GOVERNMENT OF TELANGANA
ENVIRONMENT, FORESTS, SCIENCE & TECHNOLOGY (FOR.I) DEPARTMENT

Letter No.4066/For.I(1)/2021

Sub:- EFS&T Department - F(C) Act, 1980 - Diversion of **2.6325 ha** (Revised from 4.1083 ha) of forest land for BT Road from "R/F PWD Road to Jhaduguda(PWD Road to Kishan Thanda) in Bheempur RF Block, Asifabad forest division of Komurambheem Asifabad District in favour of District Panchayath Raj Engineer (PIU), Komurambheem Asifabad District - **Furnishing of Additional information** -Regarding.

Sub: TSFD - F(C) Act, 1980 - PMGSY Roads (PR Department) - Diversion of **2.6325**
- **ha** (Revised from 4.1083 ha) of forest land for BT Road from **"R/F PWD Road to Jhaduguda** (PWD Road to Kishan Thanda) in Bheempur RF Block, Asifabad forest division of Komurambheem Asifabad District in favour of District Panchayath Raj, Engineer (PIU), Komurambheem Asifabad District- Submission of Additional information - Regarding.

MAP NO. 56
SHEET 1A, 1B, 1C, 1D, 1E, 1F, 1G, 1H, 1I, 1J, 1K, 1L, 1M, 1N, 1O, 1P, 1Q, 1R, 1S, 1T, 1U, 1V, 1W, 1X, 1Y, 1Z

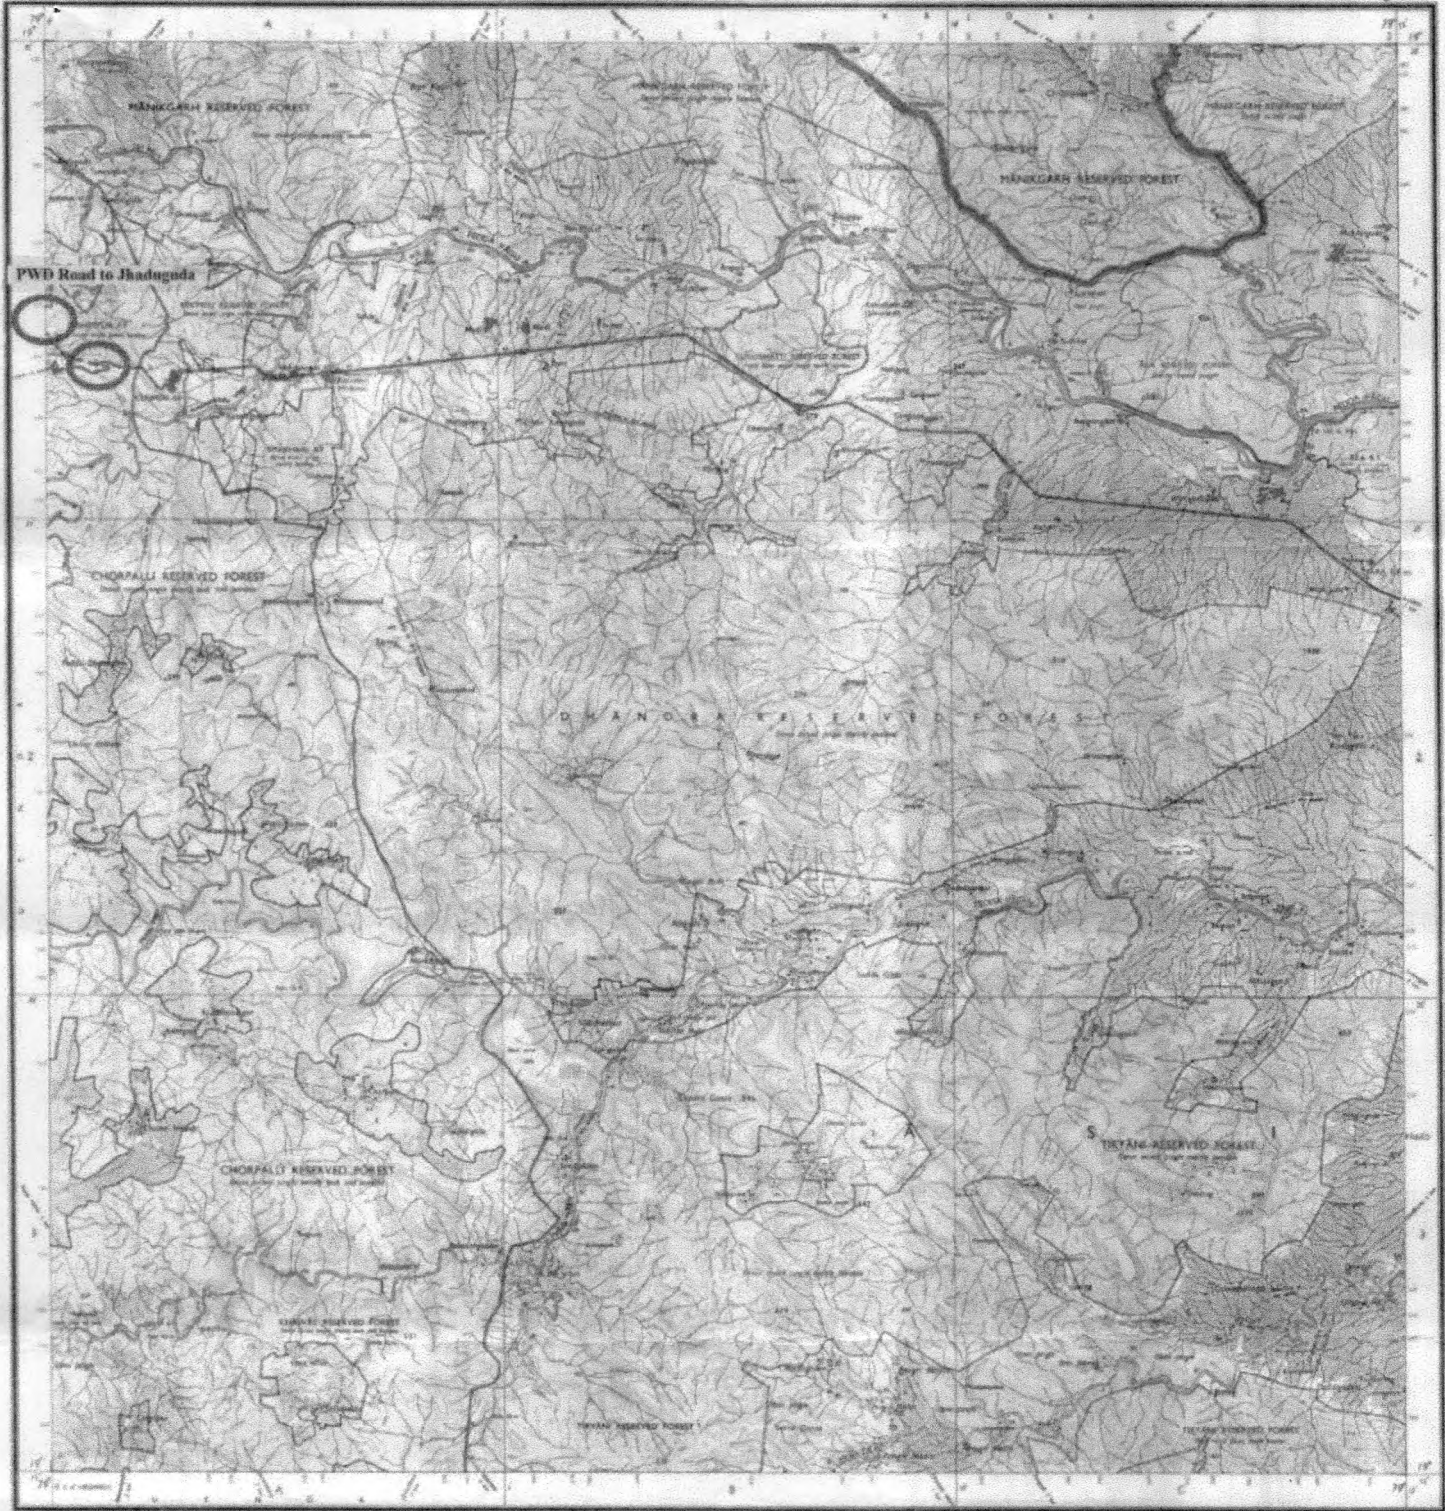
(ii)	Proper documentary evidence like RF notification etc., on existing road i.e., RoW allowed or otherwise, if allowed, actual length and width of the road allowed etc., shall be submitted.	The proposed road is passing through RF Bheempur. There is no explicit mention about RoW for these RF block in the available gazette notification and other documents.

1. From the toposheet, it can be seen that there are 7 bridges/culverts proposed in the forest land. However, the forest land proposed for diversion in such places is only 7.5 m in width only. Specific comment is requested from the UA on whether construction of bridges/culverts is possible in the 7.5 m width proposed for diversion without breaking up the adjacent forest land not proposed for the diversion.

As per 1980 and it is mapped on SOI (Map sheet No. 56M/4 is surveyed in 1975-76 in first edition 1982) is submitted that there was an existing cart track for an length of 1400 mtrs only out of 3510 mtrs and same is submitted herewith.
(iii)	From the Toposheet, it can seen that there are 7 brides/culverts proposed in the forest land. However, the forest land proposed for diversion in such places is only 7.5 m width only. Specific comment is requested from the UA on whether construction of bridges/culverts is possible in the 7.5 m width proposed for diversion without breaking up the adjacent forest land not proposed for the diversion.	It is submitted that, the User agency i.e., District Panchayat Raj Engineer, Kumarambheem Asifabad vide reference 2 nd cited above has submitted that, Seven (07) number of culverts are proposed with 7.50 mts width in the forest land which is enough for construction of Seven (7) number of culverts.

1. Seven (07) number of Culverts are proposed with 7.50 Mts width in the forest land which is enough for construction of Seven (07) number of Culverts.
